## STAR ONLINE PUBLICATION

**Case Number:** S2502000002

**Symptom/Vehicle Issue:** Clunk Pop Noise From Front End While Driving.

### Fig 1 Tech Tip Information For Replacement Stabilizer Bar Anti-Rotation Bracket

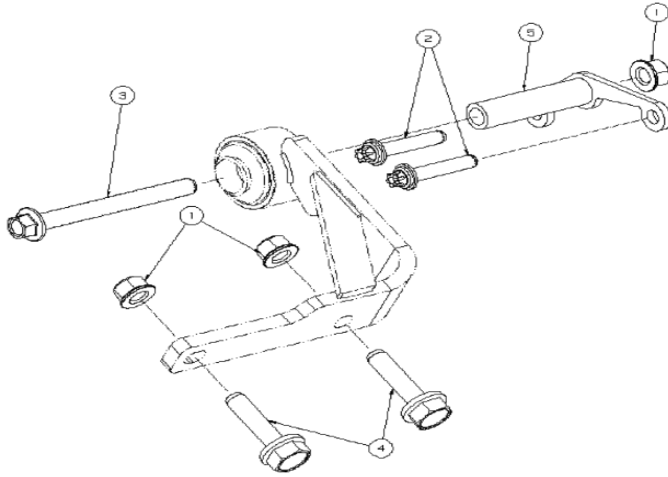
**Tech Tip Description:** BSR from the front end due to Smartbar (disconnecting front sway bar). Root cause was identified as anti-rotation bracket (connects the actuator to the stabar) coming loose due to inadequate clamp load at the joint and weld (holds the bolt shaft and bracket flange) was poorly designed. If any vehicle causes BSR because of this Bracket failure (loose joint/ bracket bends) DO NOT replace whole stabar assembly, instead replace with the service kit (PN#68730602AA). Dealer must need to order the parts from part ordering system for this claim. This kit contains 1 bracket (PN 68730603AA), 3 M10 Nut (PN 68730605AA), 2 M8X1.5 Bolt (PN 68730606AA) and 2 M10X1.5 bolt (PN 06513427AA), 1 M10 Bolt (PN 68730607AA). This kit will also contain a new torque instruction for the bolt which holds the clamp bracket to this failed anti-rotation bracket. DO NOT apply the old torque (45+/5Nm Direct torque). The new torque is Angle controlled torque monitor (20Nm Snug torque, 110 deg Angle, monitor torque within 40-70Nm). Please use Service Library for your reference.

<<<**NOTE**>>> Replace the mount using **68730602AB** or newer. Refer to StarPARTS for the most current part information.
